APPLICATION NO.	FILING DATE	FIRST NAMED INVENTOR	ATTORNEY DOCKET NO.	CONFIRMATION NO.
10/767,459	01/30/2004	Robert S. Anderson	P-6464-US2	3936

Office Action Summary

Henry M. Johnson, III

Fig. 2B

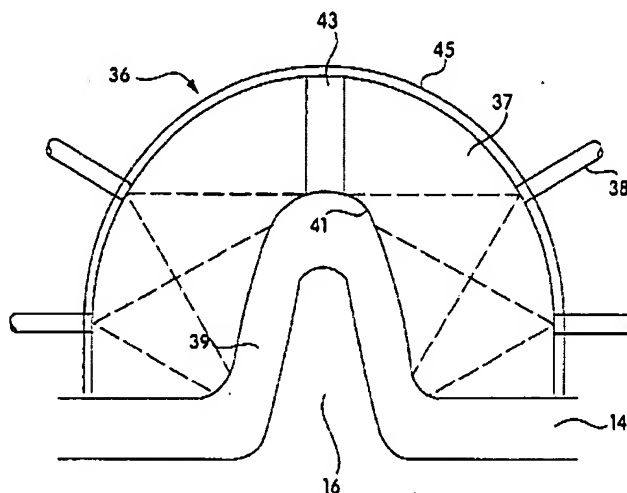
Claims 75-79 and 81-86 are rejected under 35 U.S.C. 103(a) as being unpatentable over U.S. Patent 6,605,080 to Altshuler et al. Altshuler et al. teach an apparatus and methods for treating tissue with electromagnetic radiation wherein tissue (Fig. 2B, # 39) is positioned near

radiating elements (Fig. 2B, # 38) and irradiated via the elements. Tissue is drawn into the handpiece via a suction port (Fig. 2B, # 43), the tissue being pinched and folded in the process (Col. 13, lines 35-36). It is inherent that the tissue is also stretched as it is sucked into the device. The radiating element receives

energy from a laser via optical fibers. The treatment head is optically transparent and may be made of sapphire (Col. 13, line 37) and includes a highly reflective coating (Col. 13, lines 45-50) to achieve retroreflection of the radiation. The process is disclosed as altering or killing the fat cells which are subsequently removed (Col. 5, lines 1-12) by heating the cells to specific
